12/03/2019

ADDENDUM 02

Project:
Kinesiology Labs and Aquatic Center
Liberal Arts Campus
Long Beach, CA 90806

WW Project No. 16042.01
DSA Application No. 03-119628
File No. 19-C3

TYP. EXT. PILASTER CONC. CAP @ WALL

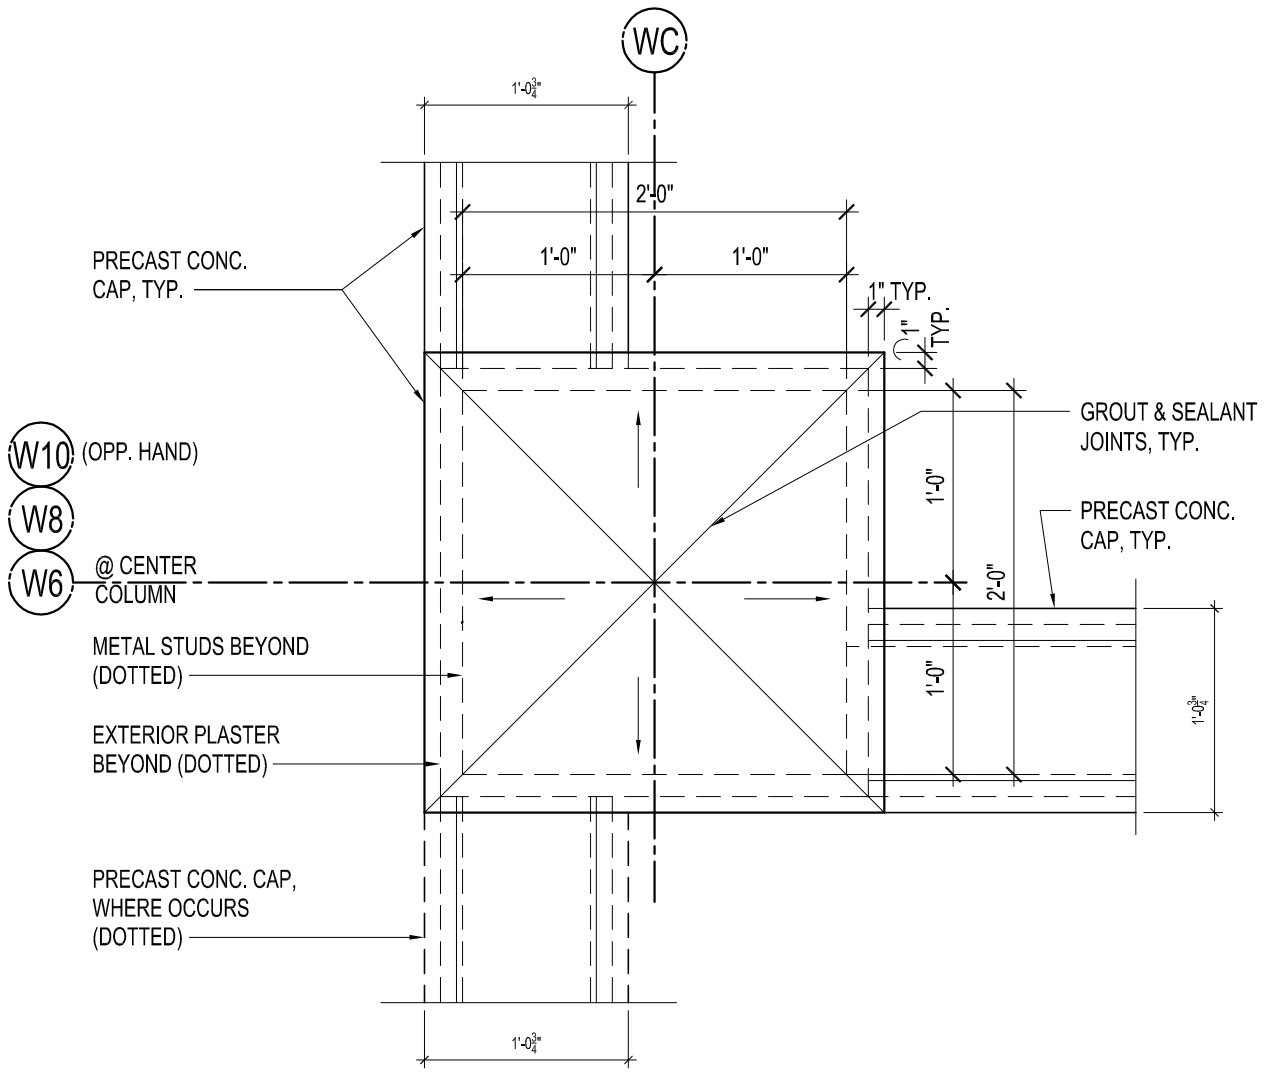
SHEET DESCRIPTION:
NEW DETAIL ON 19/A831

EXTERIOR COLUMN @ EXPANSION JOINT

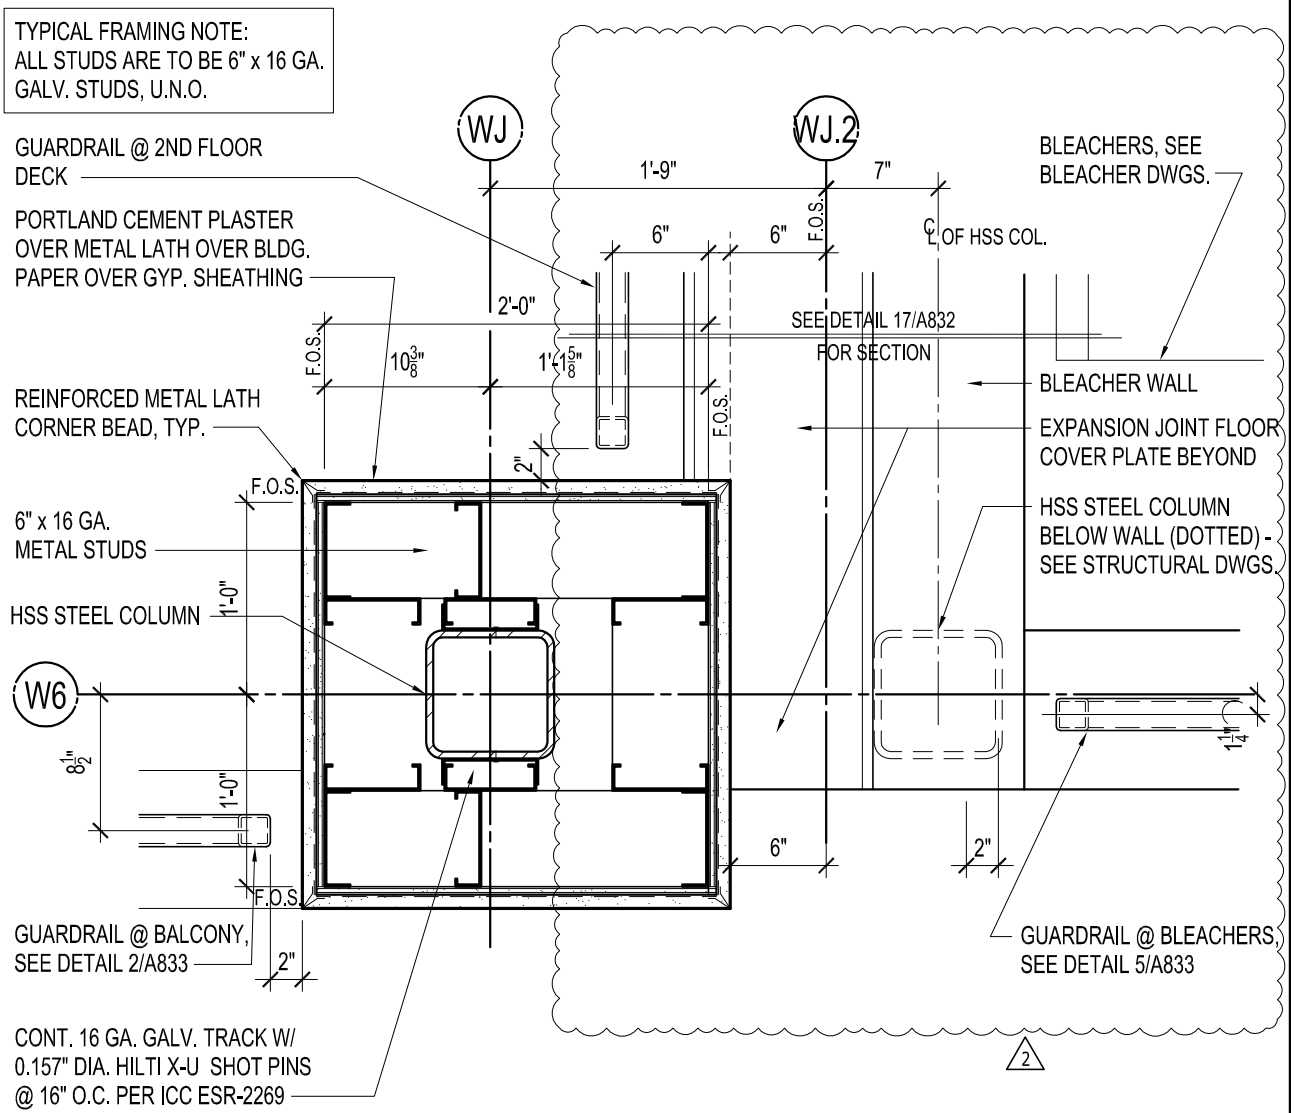
SHEET DESCRIPTION:
REVISED DETAIL 1/A832

EXTERIOR COLUMN

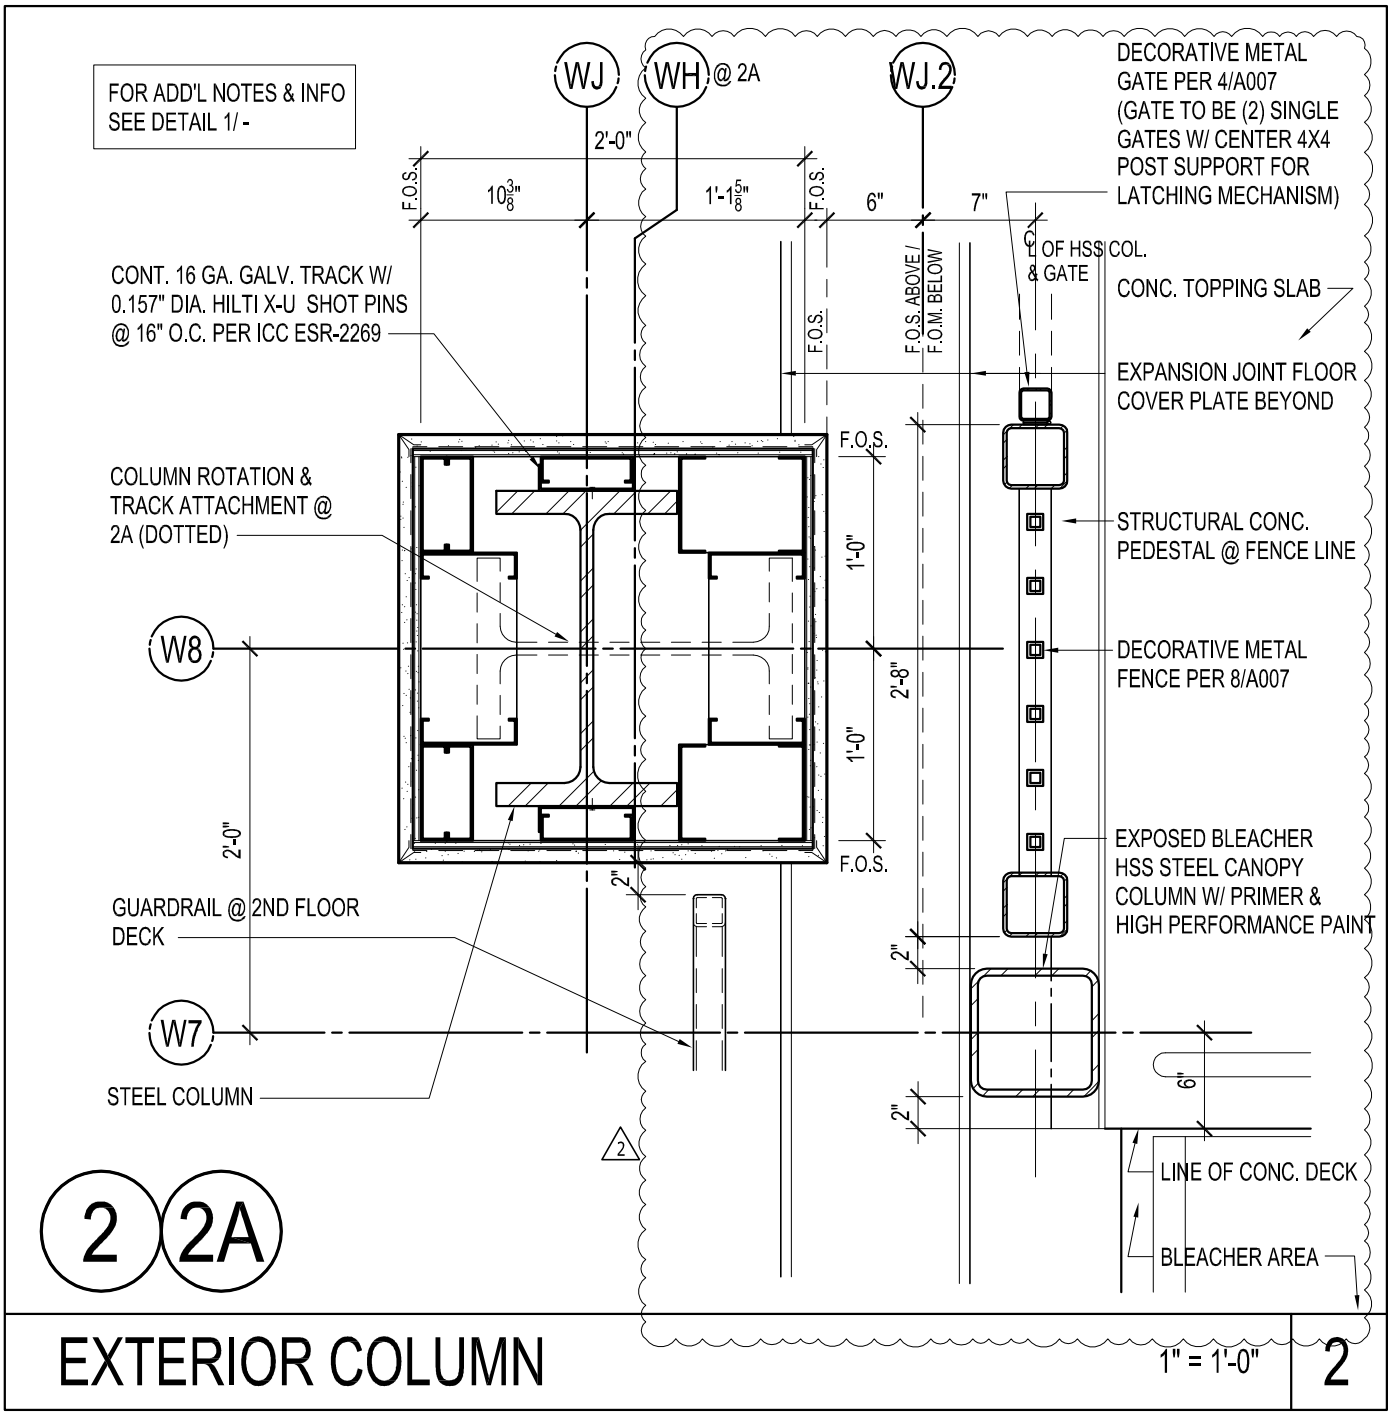
SHEET DESCRIPTION:
REVISED DETAIL 2/A832

EXPANSION JOINT

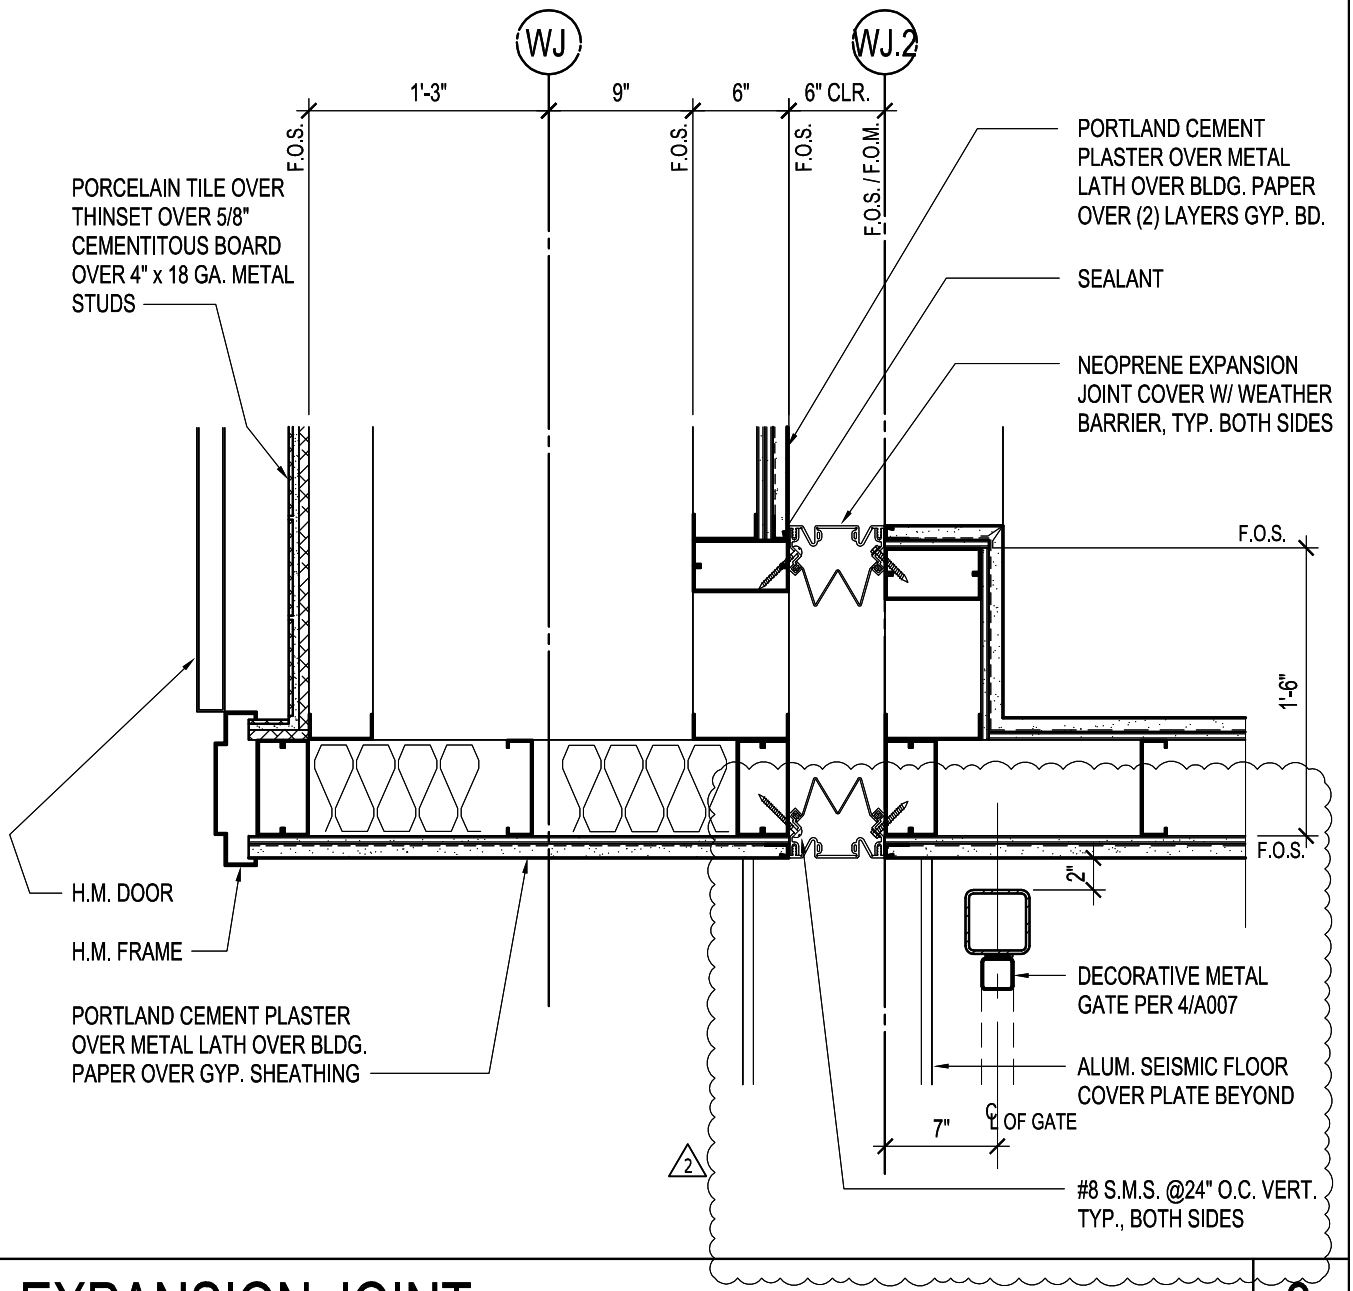
SHEET DESCRIPTION:
REVISED DETAIL 3/A832

LIGHT FIXTURE CONN. TO HSS STEEL

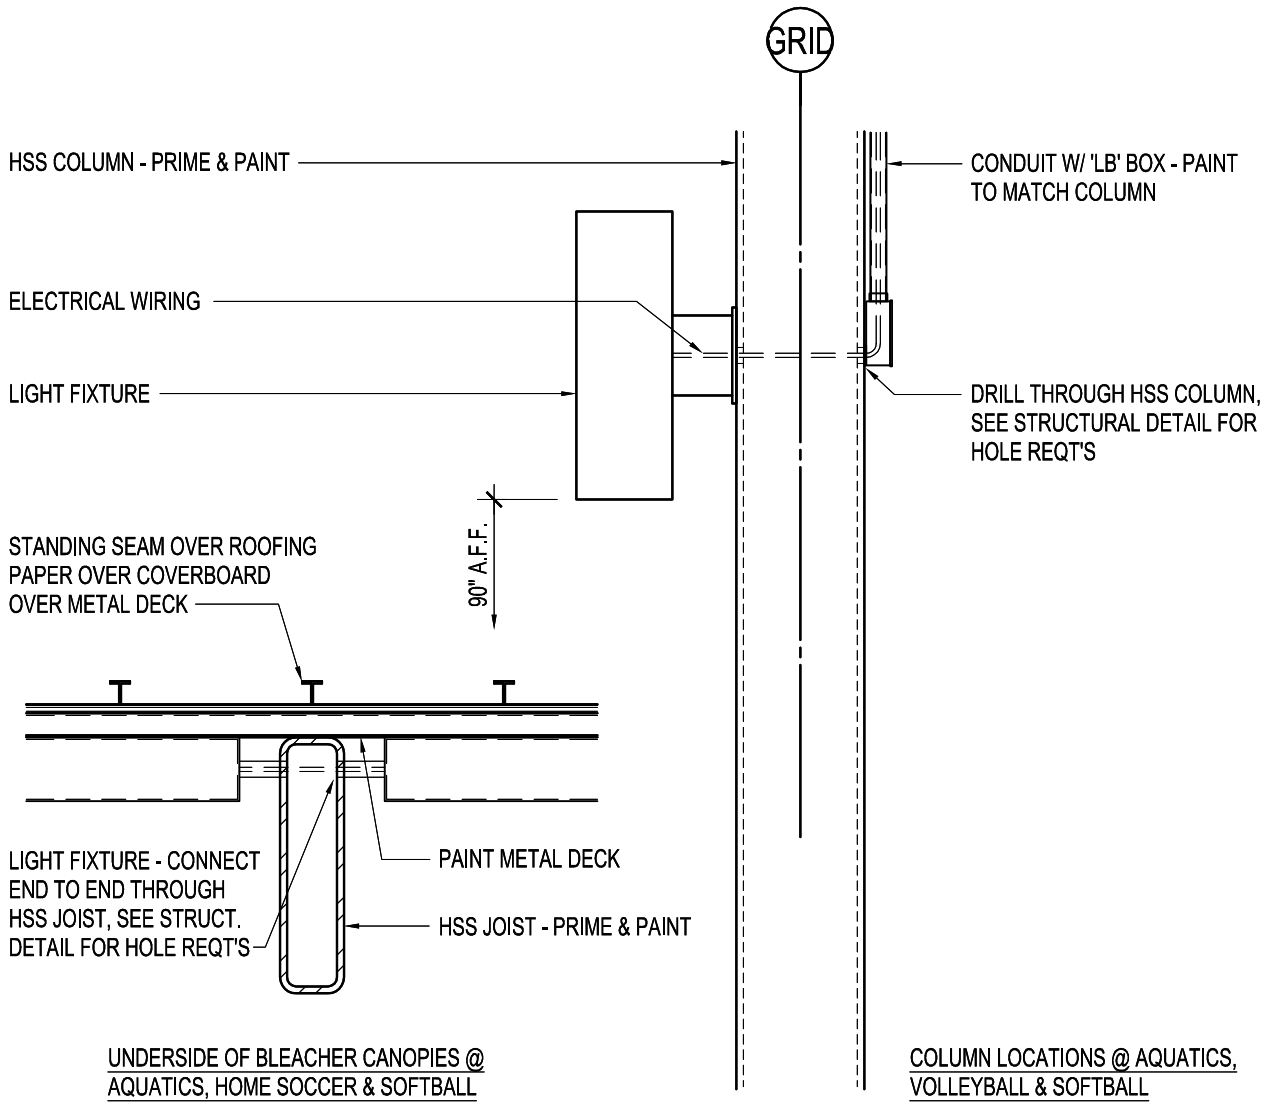
SHEET DESCRIPTION:
NEW DETAIL ON 19/A832

EXTERIOR HSS COLUMN @ BLDG. W2

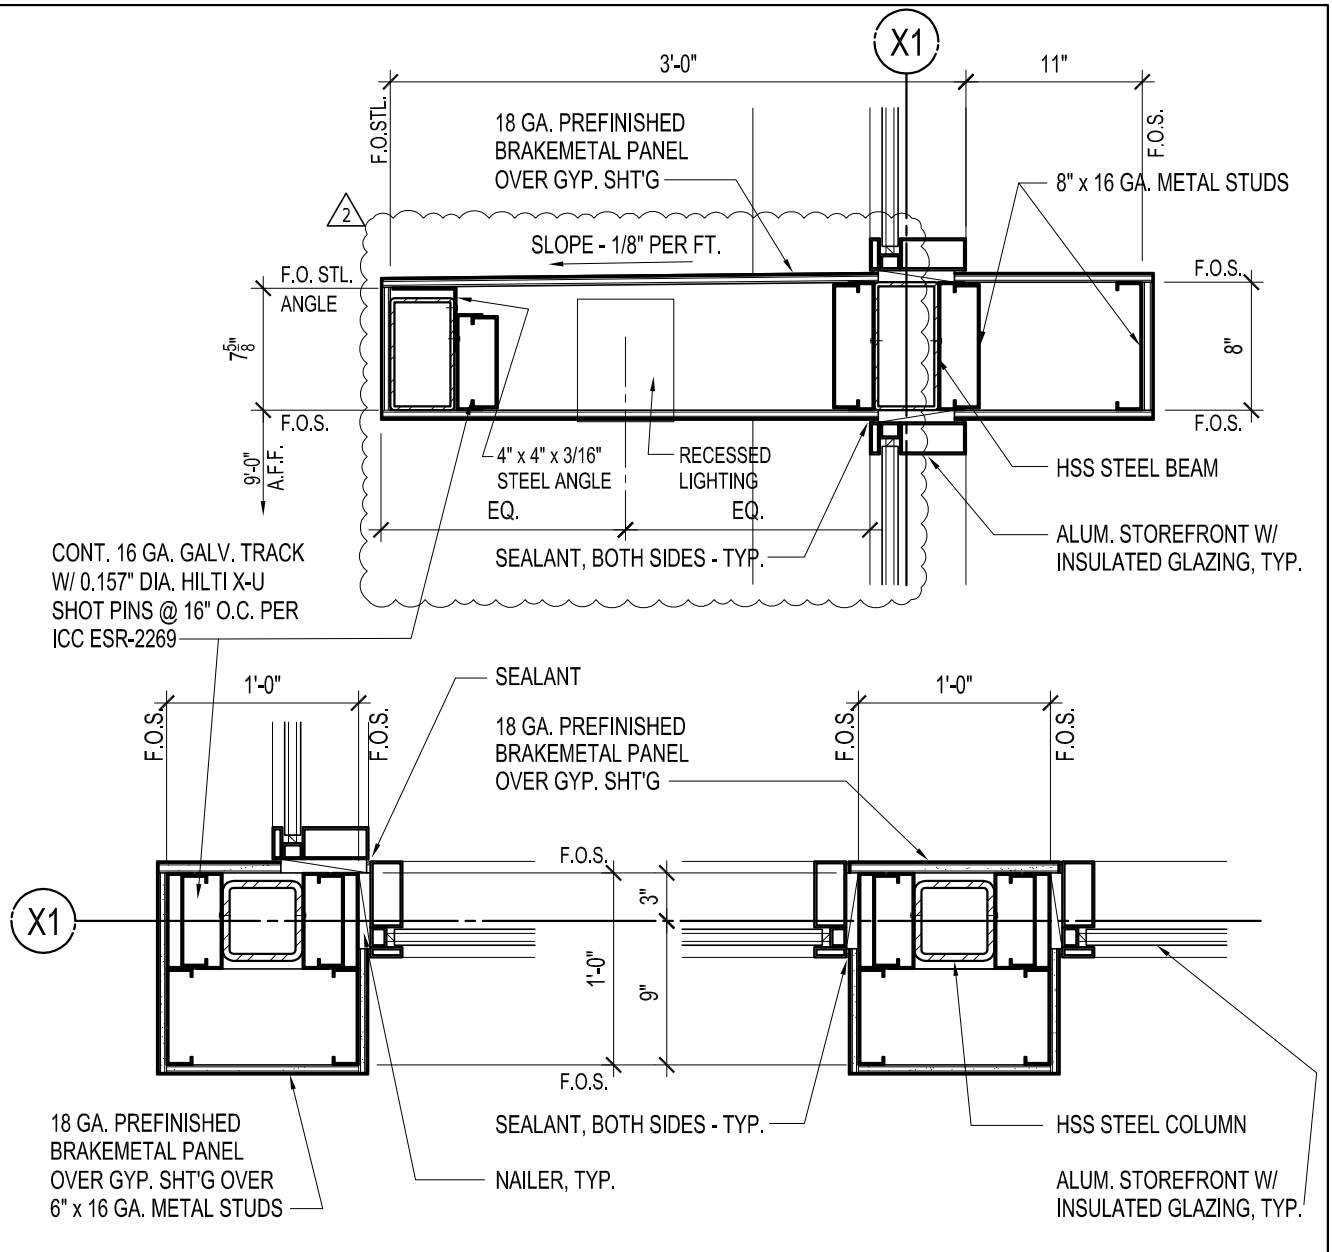
SHEET DESCRIPTION:
REVISED DETAIL 20/A832

GUARDRAIL @ BALCONY CURB

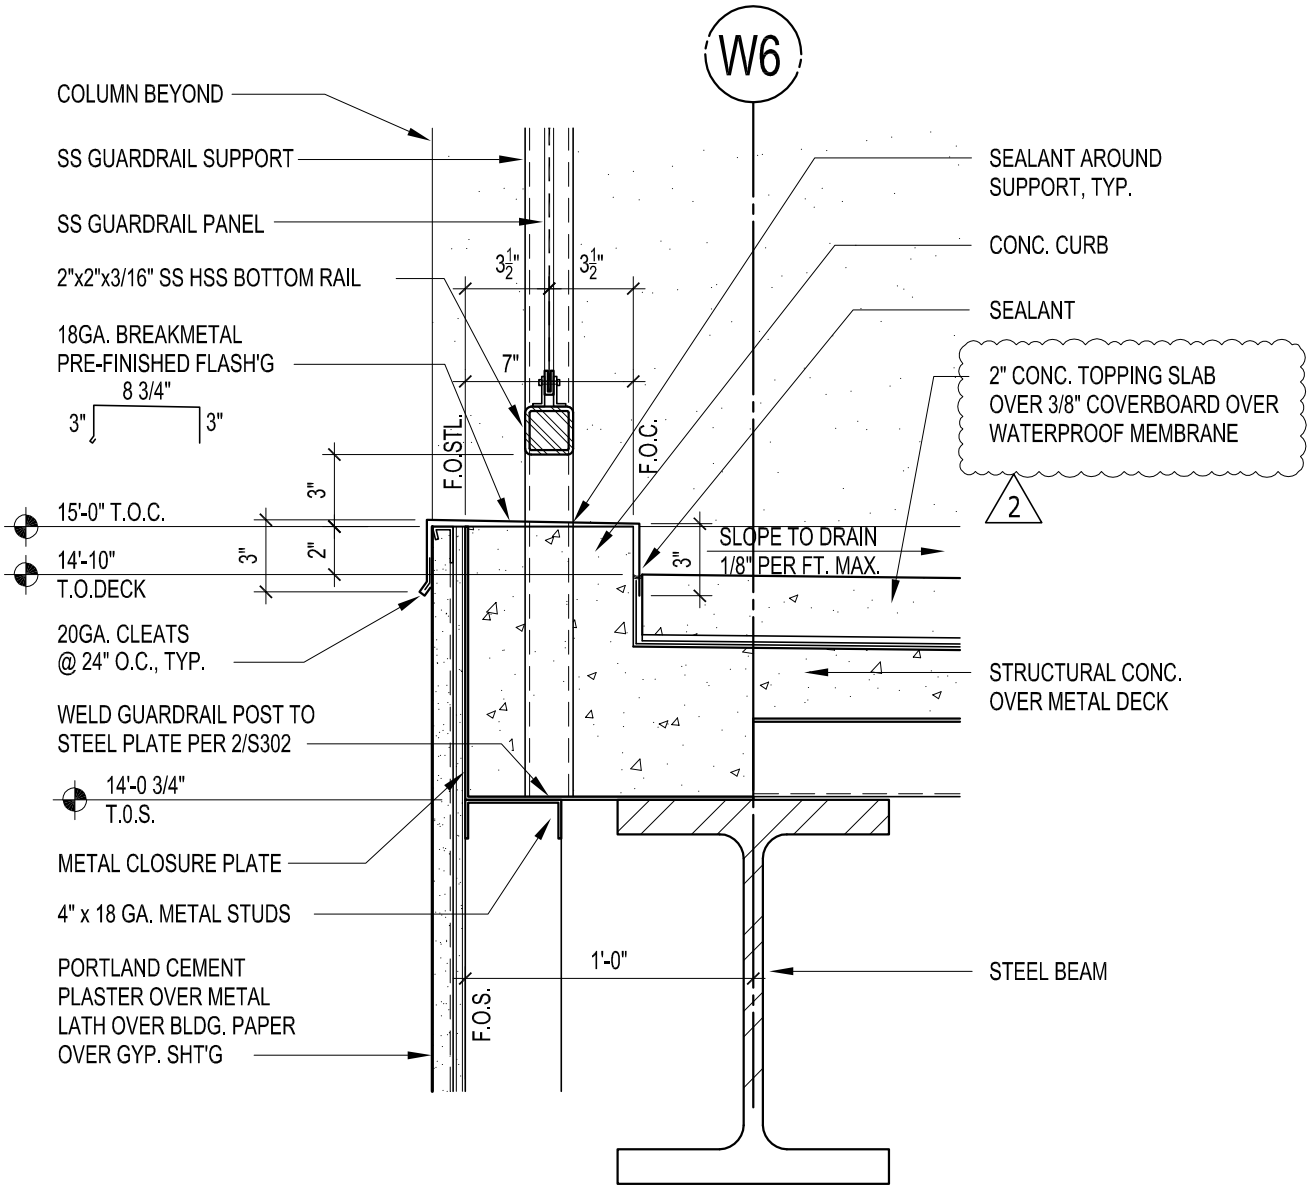
SHEET DESCRIPTION:
REVISED DETAIL 2/A833
